MEMORANDUM

RE: ZP 14-1321CA; 111 Colchester Avenue (FAHC)

Request: New approximately 208,000 sq. ft. Inpatient Building west of the Ambulatory Care Center building at the Medical Center Campus. Development includes parking lot improvements.

Map 4.5.2-3 ICC-FAHC Height Overlay. Location of proposed development identified.

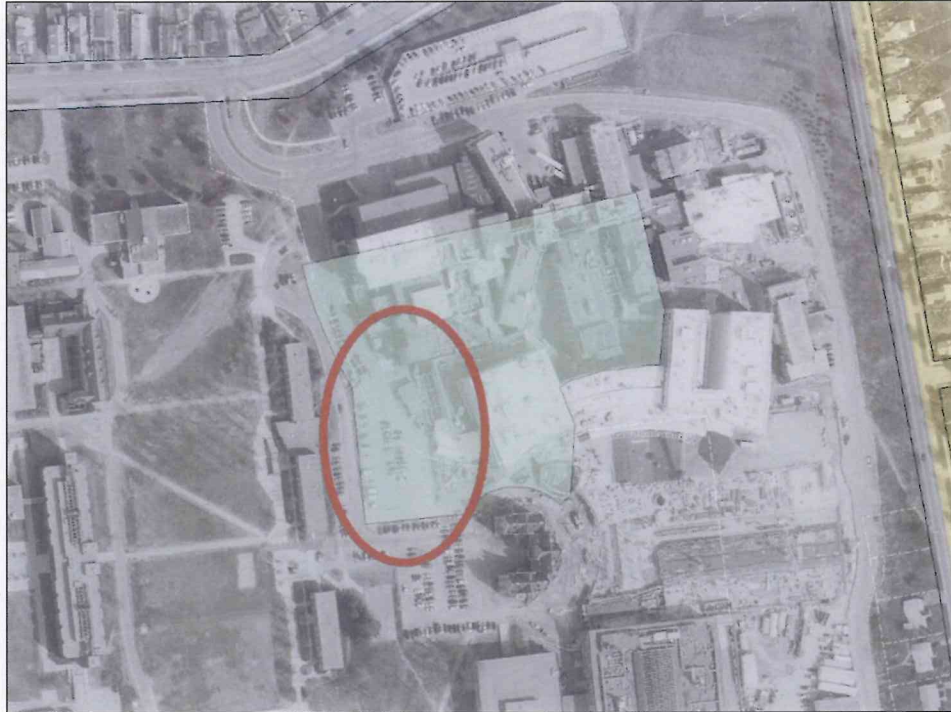
The proposed boundary line change with UVM will afford the real estate to construct the project; however portions of that Inpatient Building will extend over the ICC-FAHC height overlay and into the ICC-UVM Height overlay (See Map 4.5.2-3 ICC-FAHC and 4.5.2-4, ICC-UVM Central Campus Height Overlay).

The height of the proposed Inpatient Building, as measured to the top of the penthouse roof and illustrated on Plan AP-2.4, is 459.31' above mean sea level; below the 540' limitation of this standard.

A small section of the northerly corner of the Inpatient Building falls within the ICC-UVM height overlay. (See Plan C-1PL, Boundary Adjustment Plan.) The restrictions for that overlay district are as follows:

Exterior elevation plans AP-2.4 define grade at 358.38' above mean sea level. Subtracted from the projected height (459.31' AMSL), building height as measured along the westerly elevation of the Inpatient Building falls just shy of 101'. This meets the height limitation within the ICC-UVM Height Overlay. See narrative, *Inpatient Building, Fletcher Allen Health Care*, p. 7.

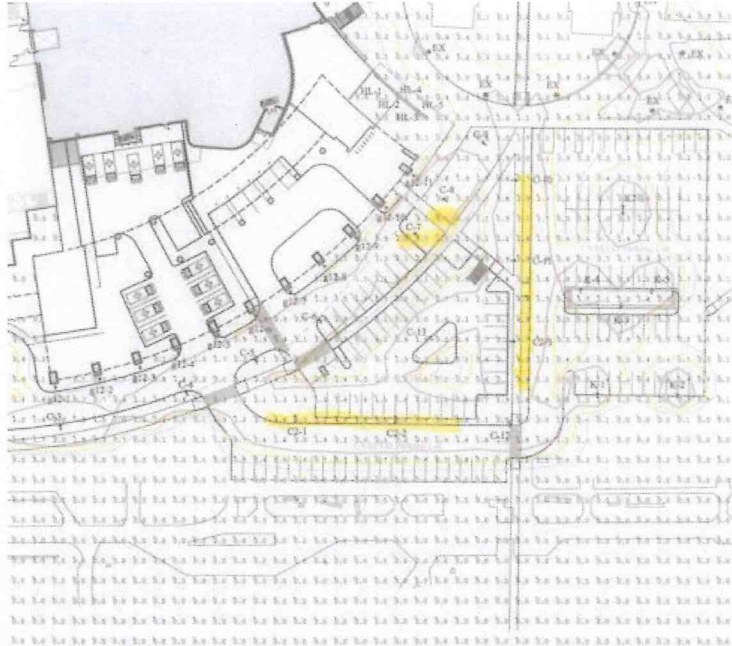
Plan LI-1.0 (photometric) reveals light levels that exceed this standard, particularly at the base of fixtures C2-1, C2-2, C2-3, and C11. These light levels will need to be adjusted to meet this standard.

On the same plan, the uniformity ratio for the FAHC parking lot is 52:00; exceeding this standard. Again, light levels will need to be adjusted to meet this standard.

An average illumination level on walkways is not provided. Several areas along walkways exceed the 2 footcandle standard; particularly under fixtures C2-1, C2-2, C-12, C2-3, C-11, and C-10. Additional high levels are under C-7 and C-8. Adjustments will be required.

All lighting will be required to meet the standards of this section, unless relief is provided under 5.5.2 7, **Security Lighting.**
